**TECHNICAL EVALUATION REPORT
OF THE IPE SUBMITTAL AND
RAI RESPONSES FOR THE
WATERFORD-3 STEAM ELECTRIC STATION**

Prepared for the U.S. Nuclear Regulatory Commission
Office of Nuclear Regulatory Research
Contract No. DE-AC02-76CH00016

This Technical Evaluation Report (TER) documents the findings from a review of the Individual Plant Examination (IPE) for the Waterford-3 Steam Electric Station (W3). The primary purpose of the review is to ascertain whether or not, and to what extent, the IPE submittal satisfies the major intent of Generic Letter (GL) 88-20 and achieves the four IPE sub-objectives. The review utilized both the information provided in the IPE submittal and additional information provided by the licensee, Entergy Operations, Inc., in response (RAI Responses) to NRC requests for additional information (RAI).

Figure 1 System Importance

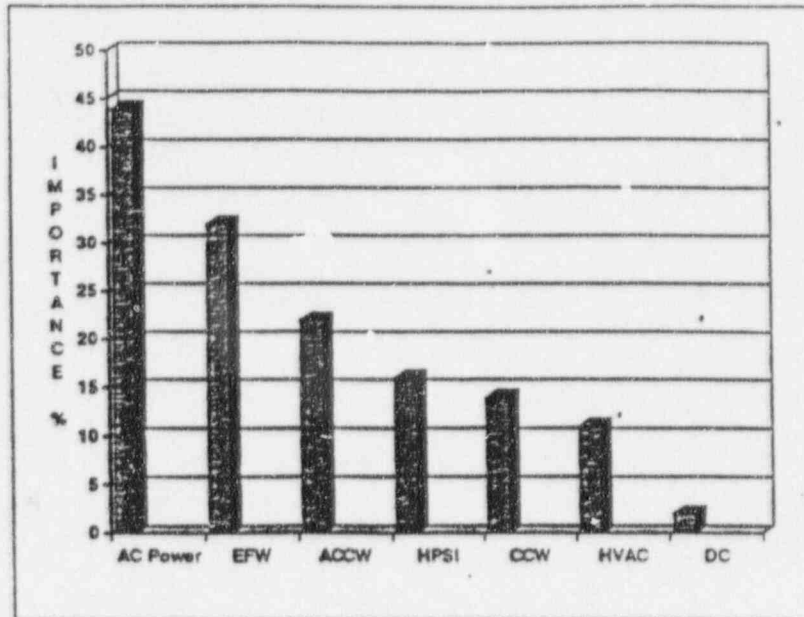
ACCW (15.1%), CCW(13.9%), HVAC (8.2%), DC power (2.2%), ESFAS (2.2%) and instrument air (0.2%). These percentages from RAI responses are somewhat at odds with Figure 1 as far as absolute numbers are concerned.
